ADDENDUM NUMBER 3
TO THE DRAWINGS AND SPECIFICATIONS

PROJECT: Livingston County Highway Department New Maintenance Building

A/E PROJECT NO: 2575 3521

2 ELEVATION
Scale: None
CG109-1L

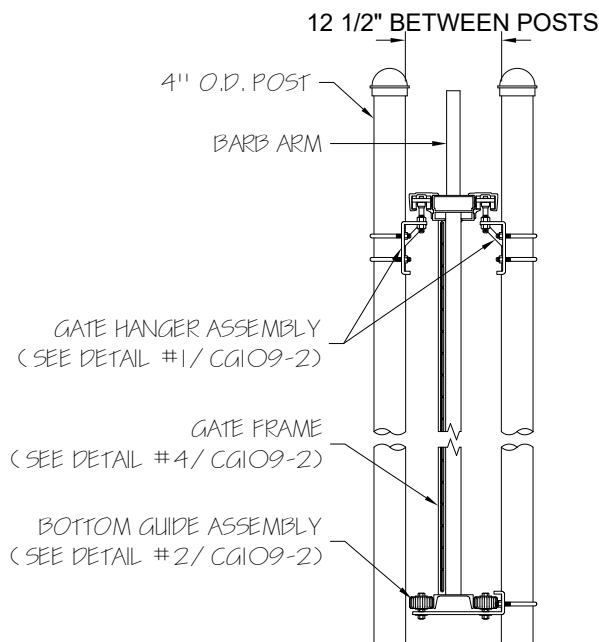
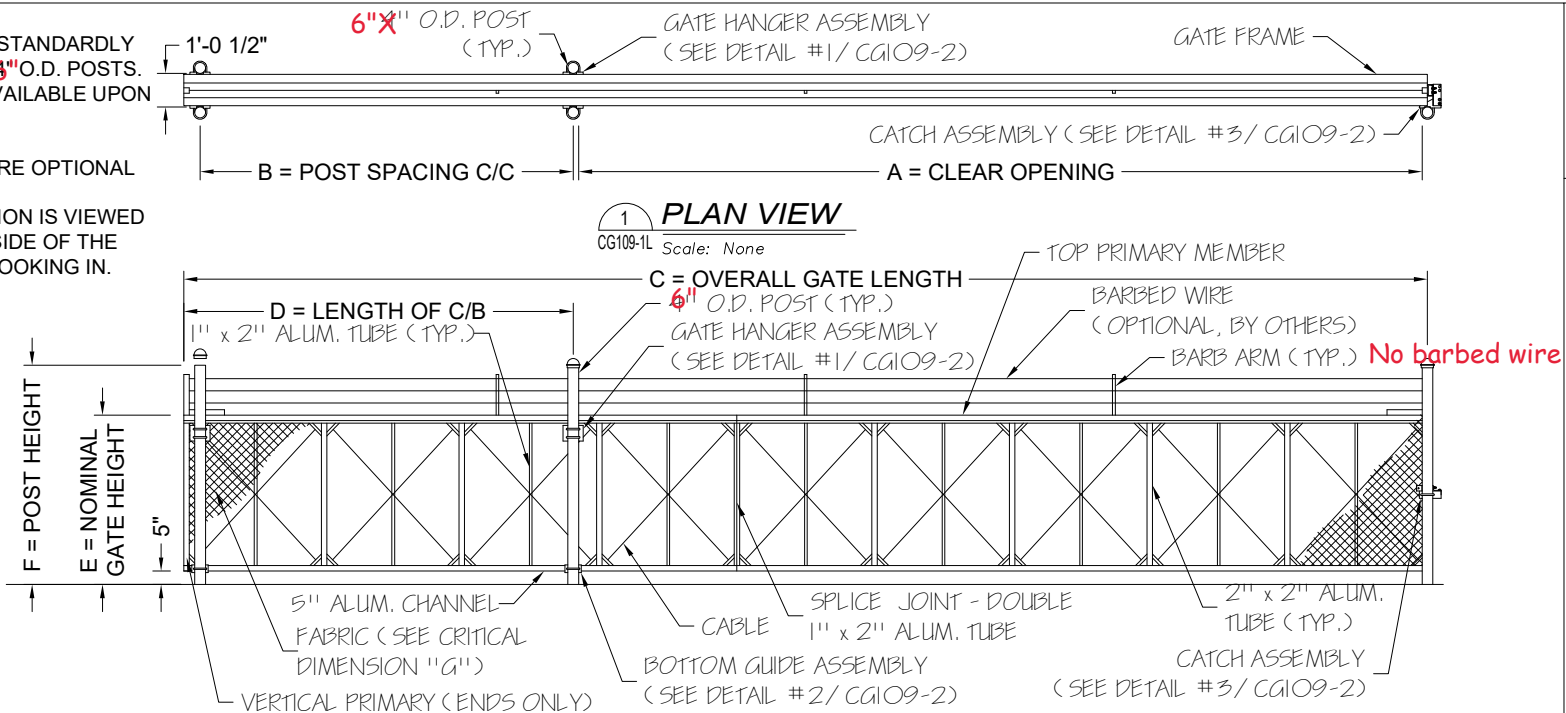
- 19 TO THE SPECIFICATIONS; Section 32 3116, 1.1.A.2. Revise the north gate from 30' clear opening to 35' clear opening. Ty Metal gate drawing is attached. This may change the gate structure for standard heavy duty to structural heavy duty verify with your selected fencing vendor the revised motor required, and roller assemblies.

Clarification, the attached Ty Metal drawing indicates minimum 4" gate structural posts, specification requires 6". Follow the larger size shown on manufacturer recommendation or the specification as occurs.
